SUBJECT: Sweetwater Uranium Project – Docket Number 40-8584 – Source Material License #SUA-1350, License Renewal - Response to the June 26, 2017 Requests for Additional Information (RAIs)

RAI Response Document

Renewal of Source Material License SUA-1350

**Responses to the Nuclear Regulatory Commission's Requests for Additional Information
Dated June 26, 2017**

Figure 2. Location of Mill Effluent Stacks (excerpted from KUC, 1994), and updated to current topography.

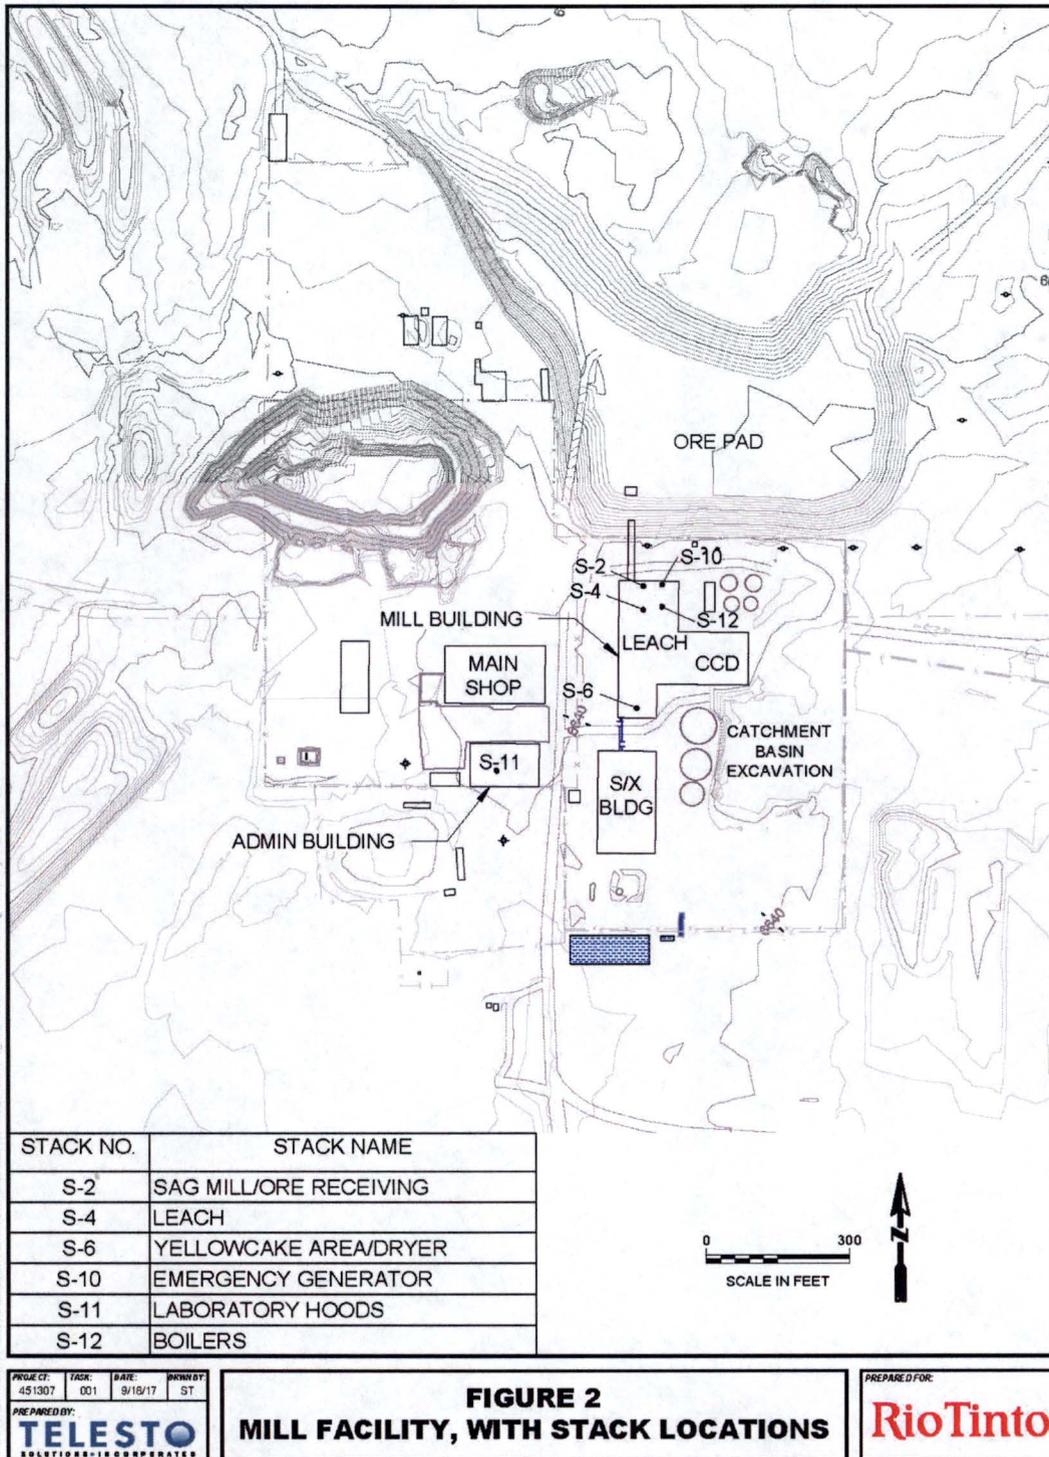
The applicant needs to provide the NRC with a copy of Procedure-15 (EP-15) Stack Sampling for NRC review. The applicant needs to provide the NRC with a methodology that demonstrates that during operations that the applicant can reduce airborne effluent releases to levels that are ALARA.

The location each effluent monitoring location is shown on Figure 2 of this response, below, and in the attached revised Standard Operating Procedure *EP-15 Stack Sampling for Particulates*. The samples will be collected from sampling ports present on the stacks. These ports have been recently (Thursday, September 14, 2017) checked and photographed.

The project had an analytical and a metallurgical laboratory during previous operations. Some analytical capabilities to routinely assay the mined ore to provide a basis for optimizing processing in response to ore properties will be needed in the future, however laboratory facilities for future operations may not be as extensive as the ones used when the facility operated from 1981 to 1983. The two laboratories may (depending upon future requirements) also routinely analyze the various process reagents and the finished product to assure adequate quality control. The fume hoods of the laboratories will collect air and an undefined mixture of chemical fumes and mists and discharge them through a stack to the atmosphere (stack S-11 shown on Figure 2 below). The effluent will not contain

**FIGURE 5
SWEETWATER WELL
LOCATION MAP**

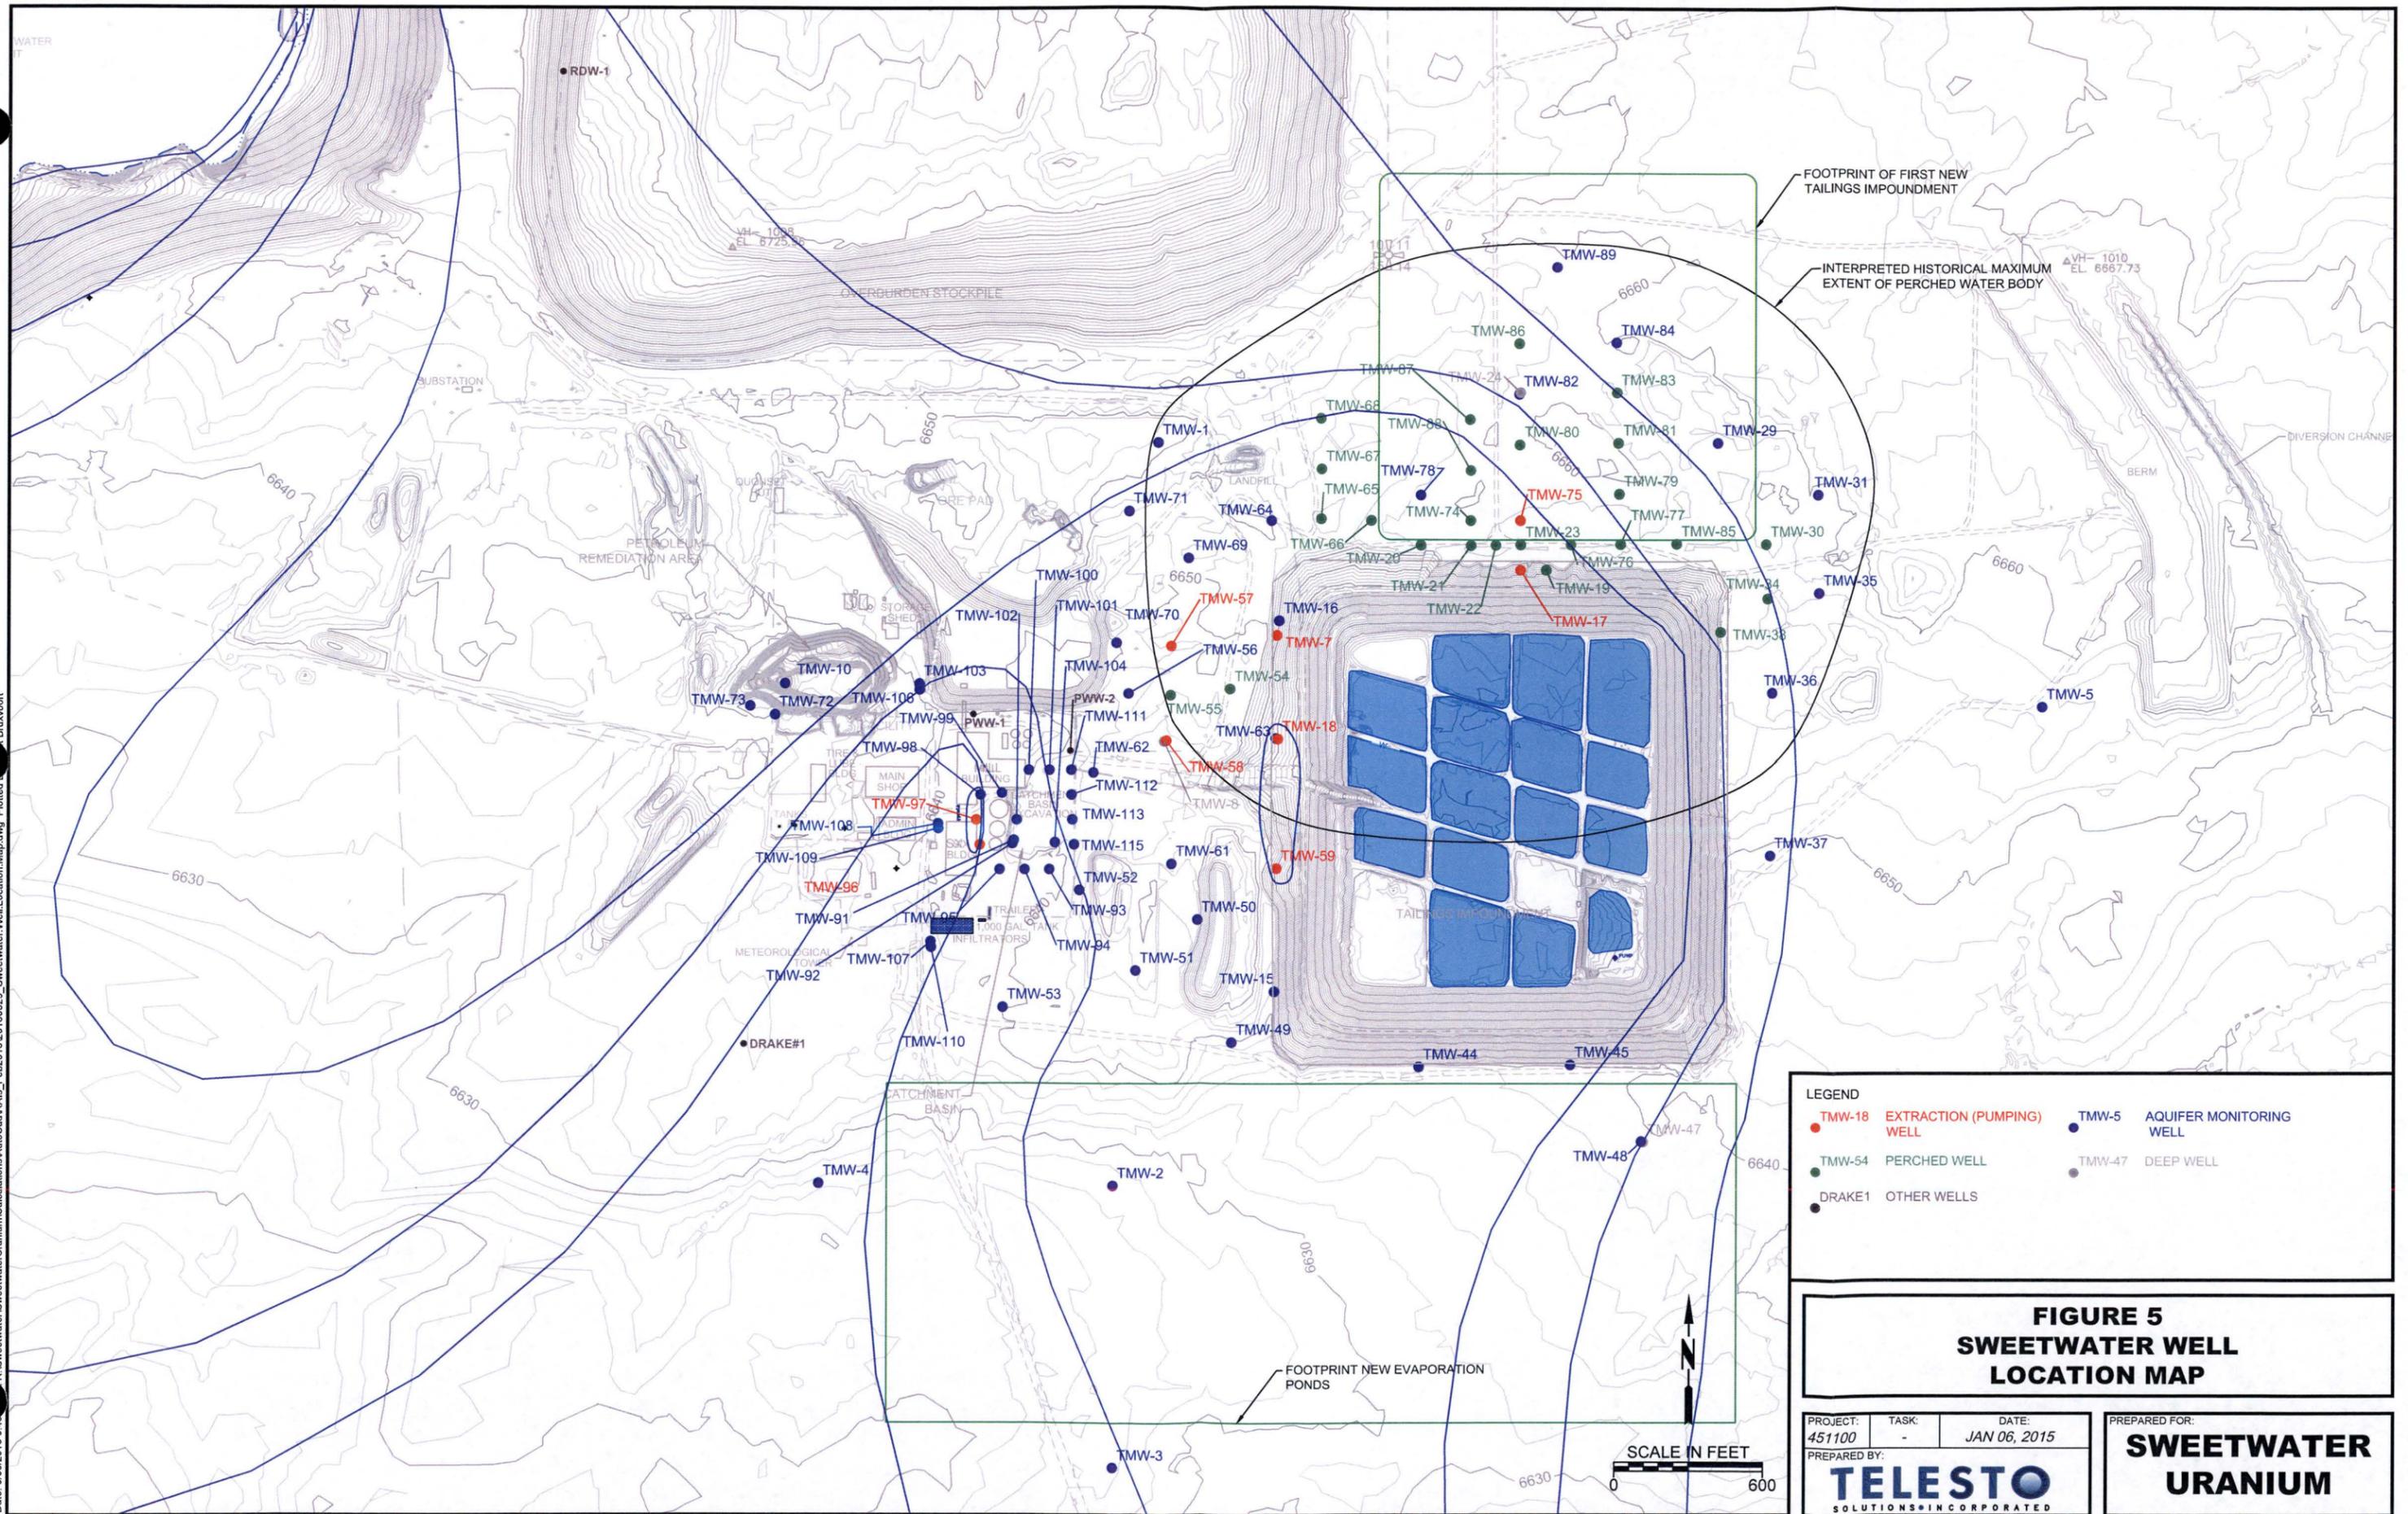
In this regard, the NRC requested additional information regarding the proposed use of bromide as a tracer and for more detail regarding the proposed groundwater monitoring program. Potassium bromide, a salt, will be the delivery mechanism to introduce bromide to the tailings system. Once dissolved in water, the potassium and the bromide become dissociated, and bromide becomes the tracer. Bromide is extremely conservative in an aqueous environment and makes for a good tracer. The purpose of this letter is to respond to RAI No. 3 and No. 4 in the context of complying with 10 CFR 40 Appendix A Criterion 7A.

The first new tailings impoundment allowed under the facility license is proposed to be located 100 feet due north of the existing impoundment, and the evaporation ponds to the south of the existing impoundment, as shown on Figure 5 which also shows the locations of monitoring wells and the approximate location of the historical extent of perched water above the discontinuous sandstone lens.

FIGURE 6 SAMPLING AND PROPOSED GROUNDWATER MONITORING LOCATIONS		
<small>PROJECT:</small> 451307	<small>TASK:</small> 02	<small>PREPARED FOR:</small>
TELESTO <small>SOLUTIONS • INCORPORATED</small>		RioTinto

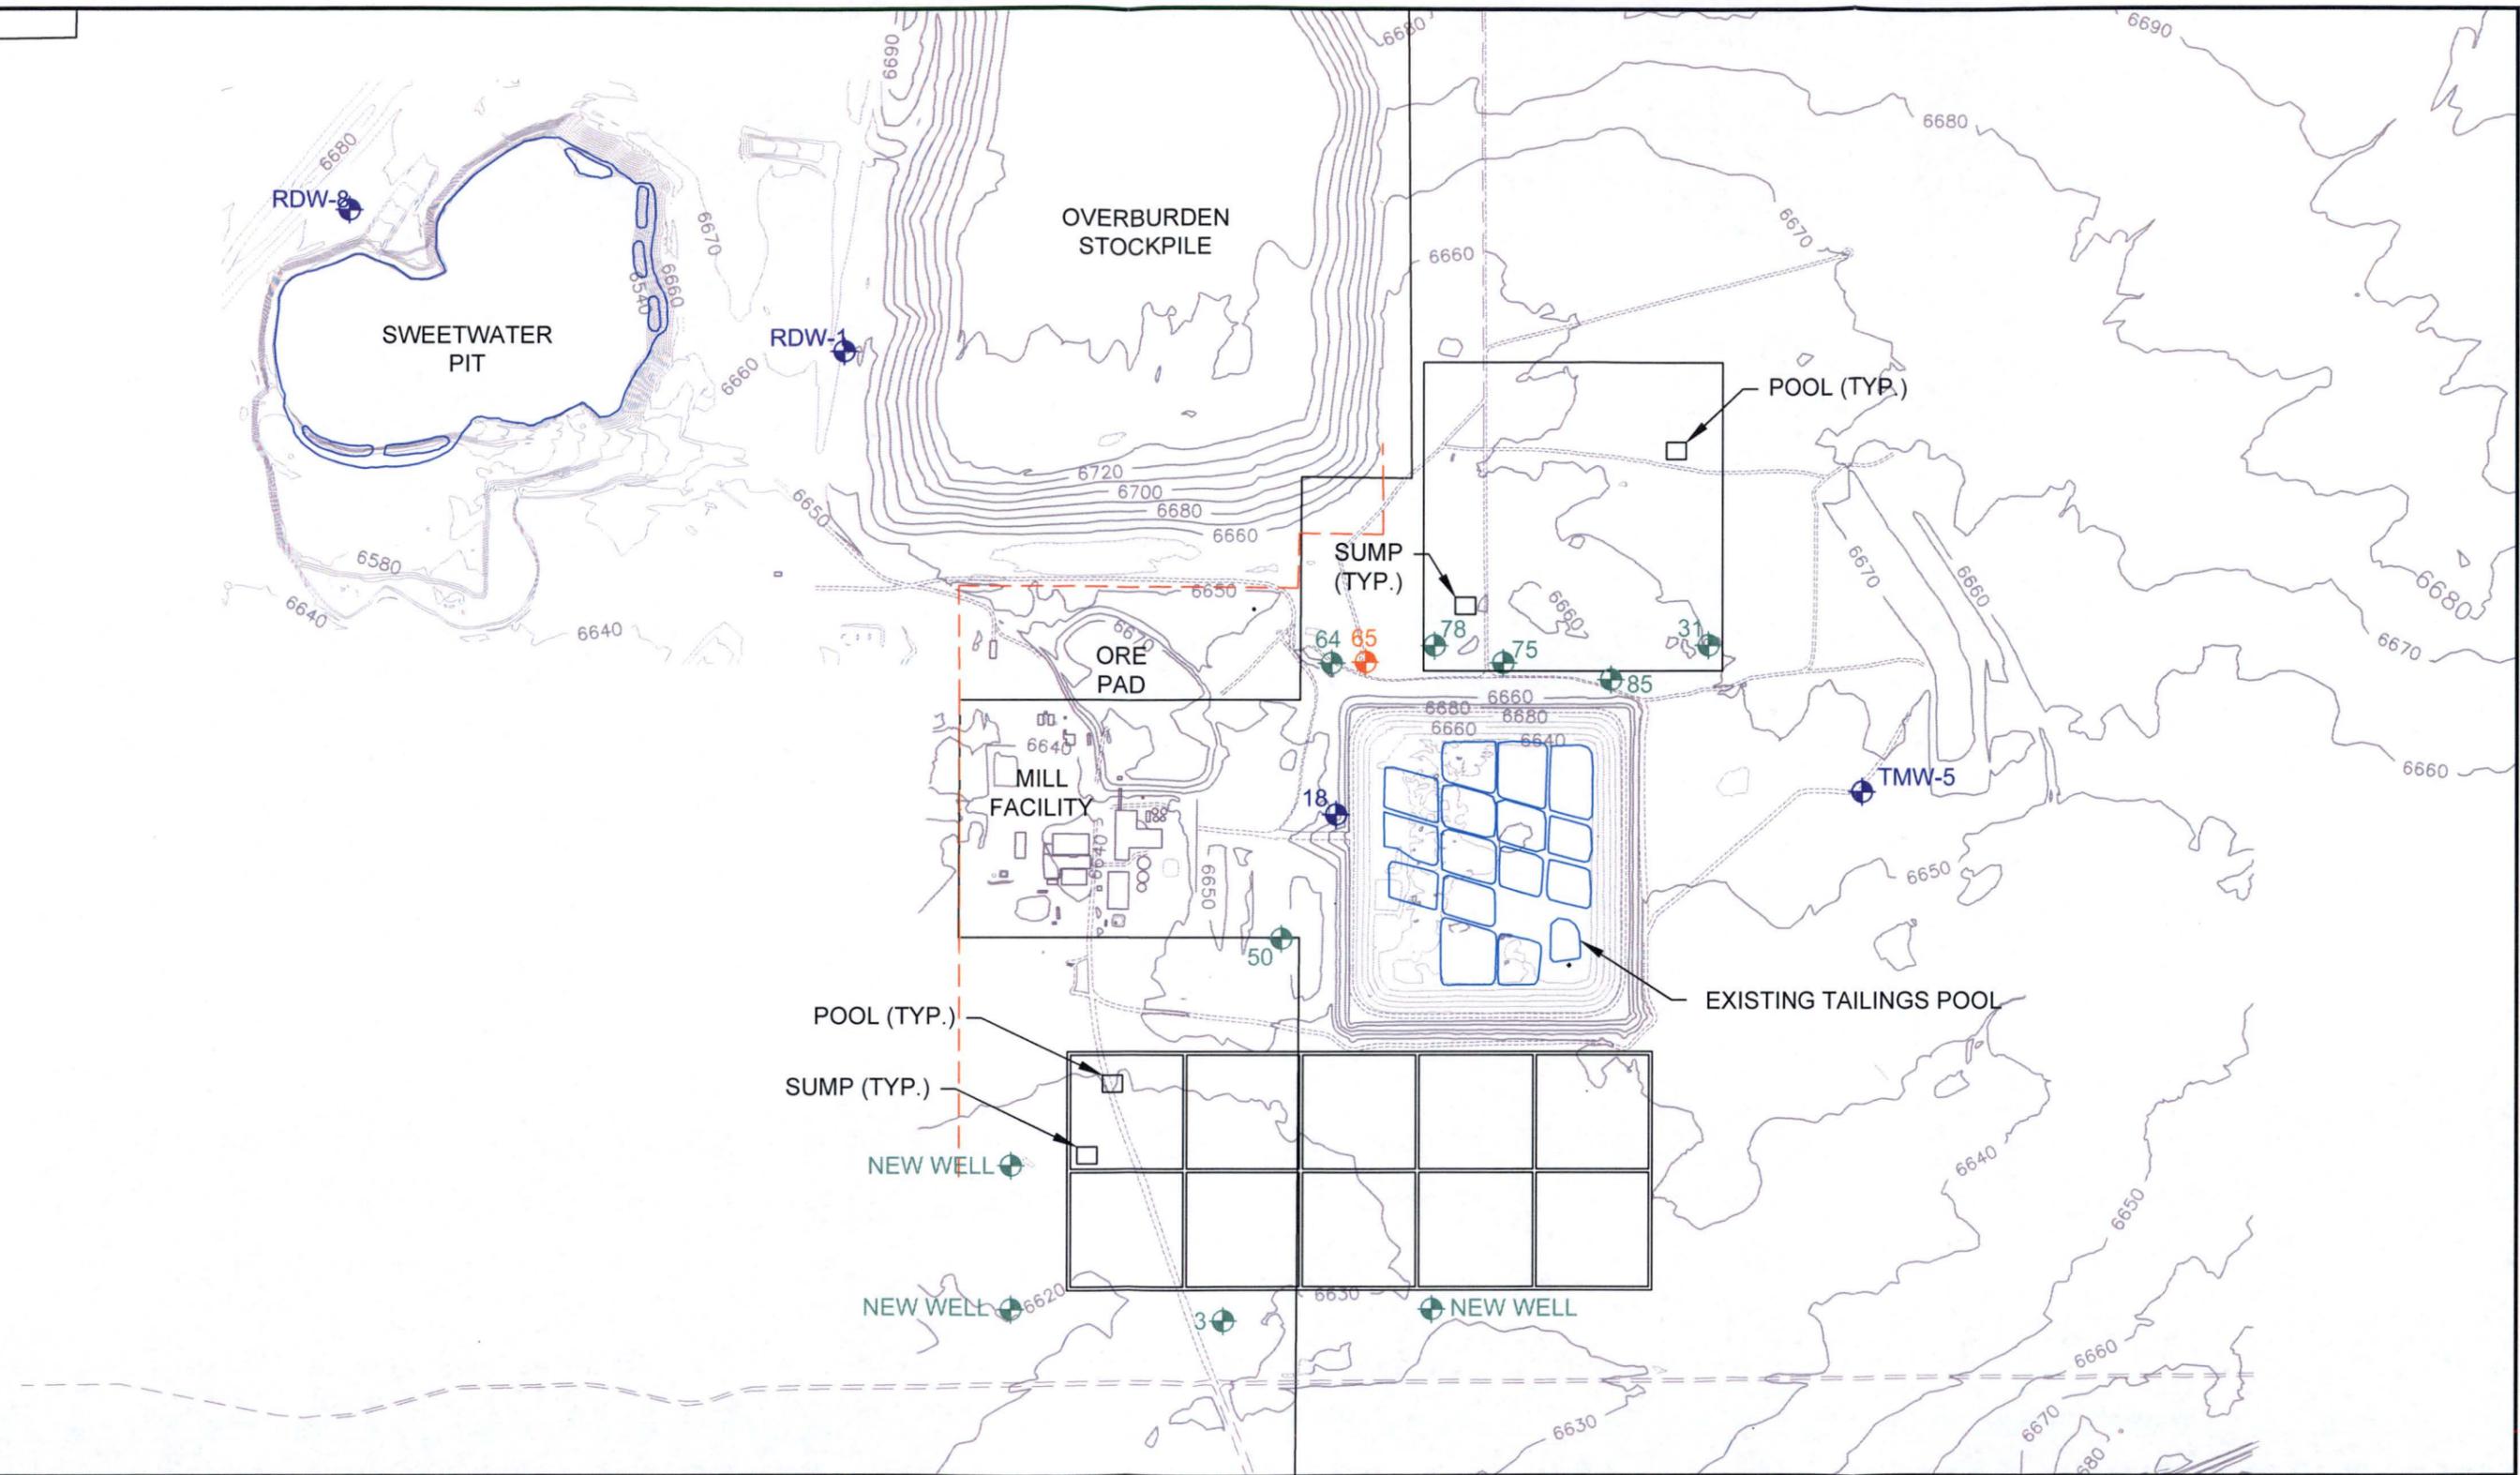
- *Provide laboratory analysis results for at least one background monitor well sample to substantiate the statement that: “Bromide is not found ... in background groundwater.”*

Samples were collected from TMW-5, TMW-18, RDW-8, and RDW-1 in June and July of 2017. Bromide was not detected above the reporting limit of 0.05 mg/L. Laboratory results are included as Attachment 10 and locations for these wells are shown in Figure 6.

Samples were collected from the free pool in the southeast corner of the tailings impoundment (Figure 6) in June of 2017. Bromide was not detected for a reporting limit of 1 mg/L. The reporting limit on the tailings fluid is higher than the other samples because the conductivity of the un-diluted sample was too high for the instrument and the sample had to be diluted. Laboratory results for the tailings fluid sample are also included in Attachment 10.

Kennecott is proposing monitoring for bromide in six monitoring wells for the tailings impoundment: TMWs 31, 64, 65, 75, 78 and 85, as shown on Figure 6 and on the revised Figures 5-3 and 5-7 from the Operations Manual (Shepherd Miller, Inc., 1997b).
